SERVICE BULLETIN

No. 645A

Piper Aircraft Corporation

<u>Subject:</u>	Crossfeed Valve Inspection
<u>Reason for Revision:</u>	To add Serial Numbers
<u>Models Affected:</u>	<u>Serial Numbers Affected:</u>
PA-31-300/PA-31/ PA-31-325 Navajo	31-2 through 31-7812108, 31-7812116, 31-7812120 through 31-7812123, and 31-7812125
PA-31-350 Chieftain	31-5001 through 31-7852138, 31-7852140 through 31-7852193
<u>Compliance Time:</u>	Within the next one hundred (100) hours of operation or at the next scheduled inspection event, whichever occurs first.

PA-31 & PA-31-325PA-31-350

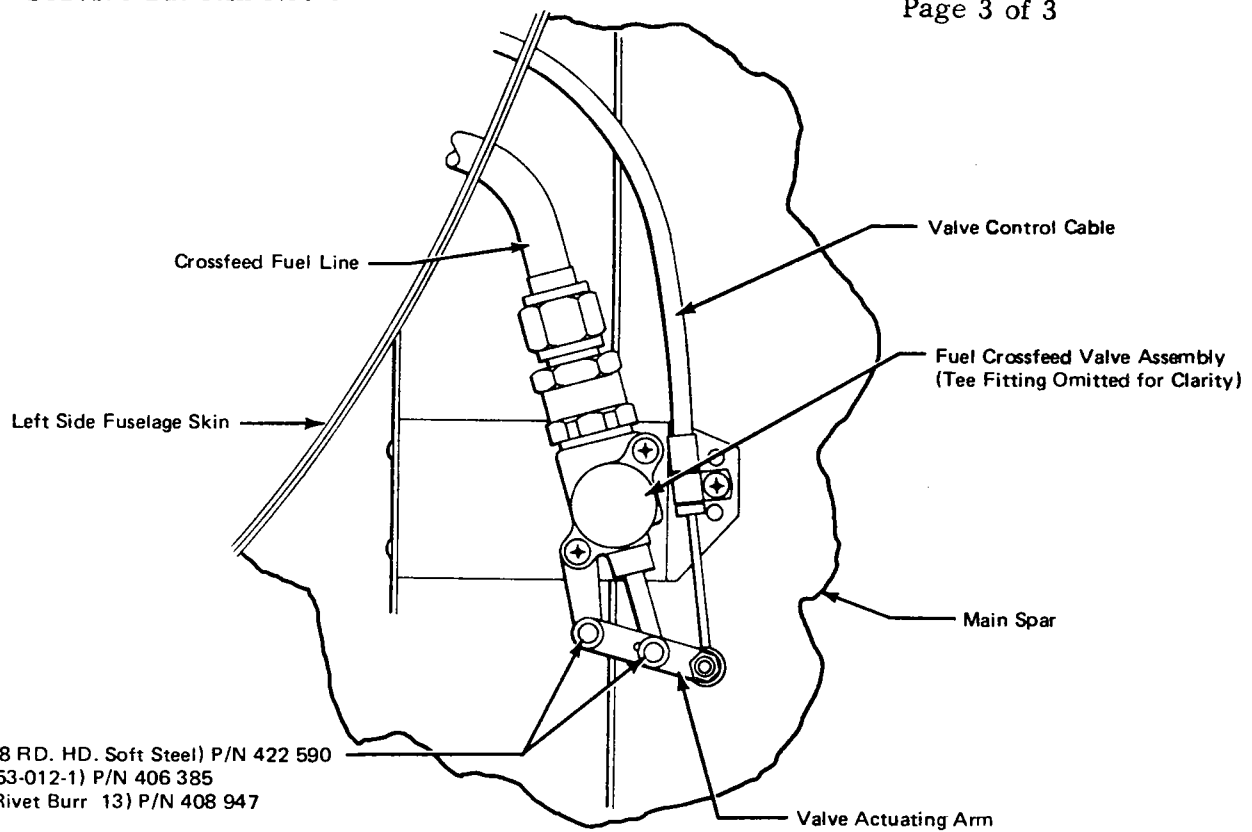
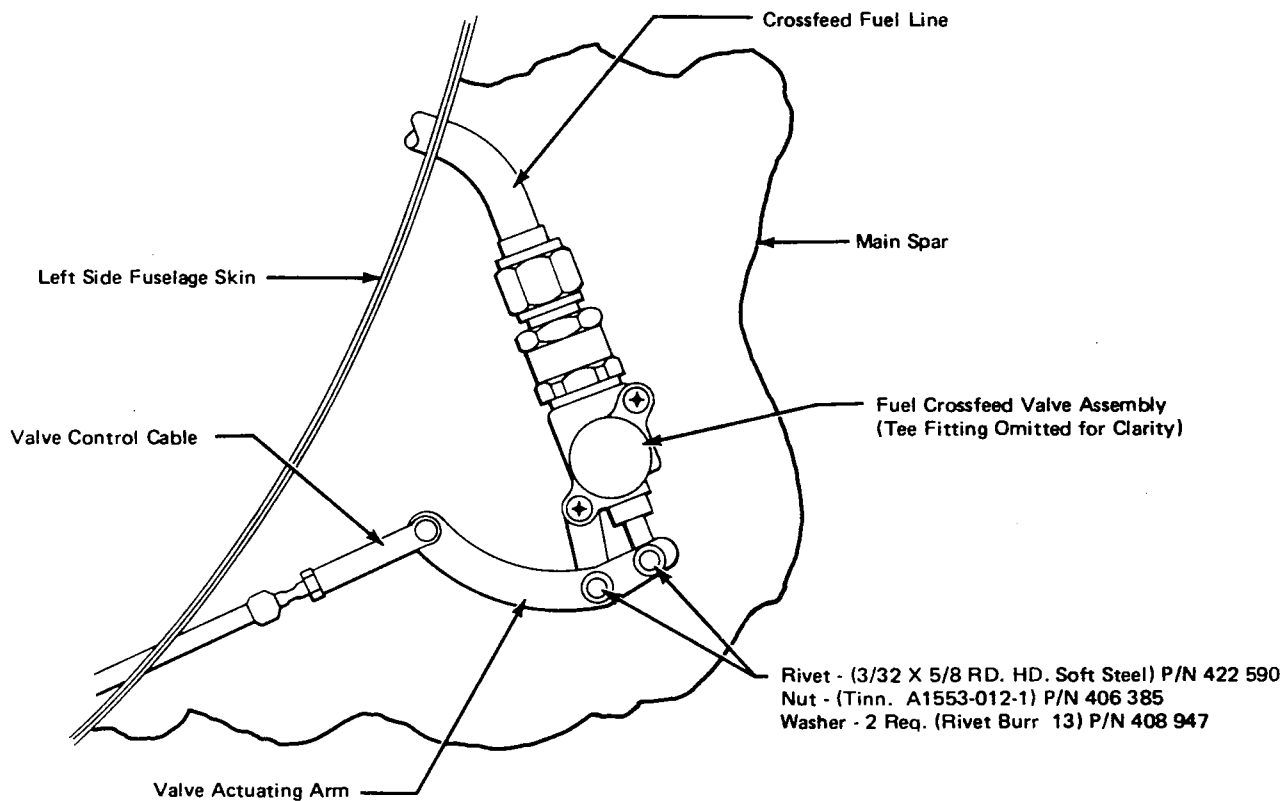
1. Gain access to the crossfeed valve (Piper Part No. 492 110) by removing the access panel on the lower left wing root.
2. Inspect the two (2) rivets securing the crossfeed actuating arm to the crossfeed valve (Refer to attached Sketch.) The aluminum rivets have a brazier type head and are non-magnetic. Soft steel rivets have a half round head and are magnetic.
3. If the rivets are soft steel (Piper Part No. 422 590), no further action is necessary. Reinstall access panel and make appropriate logbook entry of compliance.

4. If the rivets are aluminum (Piper Part No. 420 189), remove and replace Tinnermann nuts, and remove and replace any aluminum rivets (420 189) with soft steel rivets (422 590).
5. Check valve for secure attachments and proper action.
6. Reinstall access panel and make appropriate Logbook entry of compliance.

Rivet (3/32 x 5/8 RD. HD. Soft Steel) Piper Part No. 422 590, Nut (Tinnermann A1553-012-1) Piper Part No. 406 385, Washer (Rivet Burr 13) Piper Part No. 408 947.
